Determination 2011/108

The code compliance of a plywood joint to a house at 25 State Highway 25, Kopu, Thames

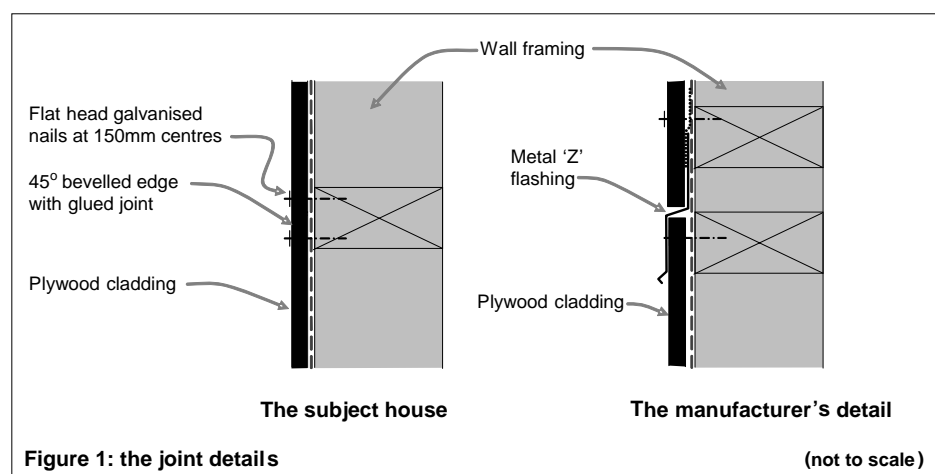
- 2.3.1 The joint detail is to the horizontal joint in the gable-end walls of the subject house. The plywood sheet edges are bevel-cut on site and edges are treated and primed. When the upper sheet is installed, glue is applied to both surfaces of the cut edges.
- 2.3.2 Based on the builder's sketches and the expert's description, the joint detail to the subject house and the applicable manufacturer's detail at the time appear to be as shown in Figure 1:

- it was not clear whether the letter written by the manufacturer in 2004 referred to the joint detail in dispute
- the detailing for the joint does not describe treating and priming edges or how to apply adhesive
- the adhesives used in this instance are, in the manufacturer's opinion, unsuitable for an external situation
- the detail was dependant on onsite workmanship which was key to performance.

- Sheets are nailed with 40mm flathead nails at 150mm centres and overlap at a 45° saw cut, which is bonded with water-resistant adhesive. According to the builder, all cut edges are treated with site-applied timber preservative and excess glue is removed with a knife once it is set.
- Close scrutiny reveals that the joint has been ‘well executed’, with ‘no signs of failure or premature deterioration’. The joint is a tight fit and has been nailed at 150mm centres. Glue residue visible within the grooves indicates that adhesive had been ‘generously applied’
- The success of the detail relies heavily on workmanship, which needs to be closely monitored to ensure the joint is executed correctly.
- Comprehensive invasive moisture readings were taken, which indicated that the joint is performing satisfactorily and moisture is not entering the framing.

- 6.4 Taking account of the above, I am satisfied that the joint detail as installed to this particular house is satisfactory in the circumstances and that the joint complies with Clauses B2 and E2 of the Building Code.

- 7.1 In accordance with section 188 of the Building Act 2004, I hereby determine that the plywood cladding joint detail as constructed in the subject house built under building consent ABA 2007/191 complies with Building Code Clauses B2 and E2.
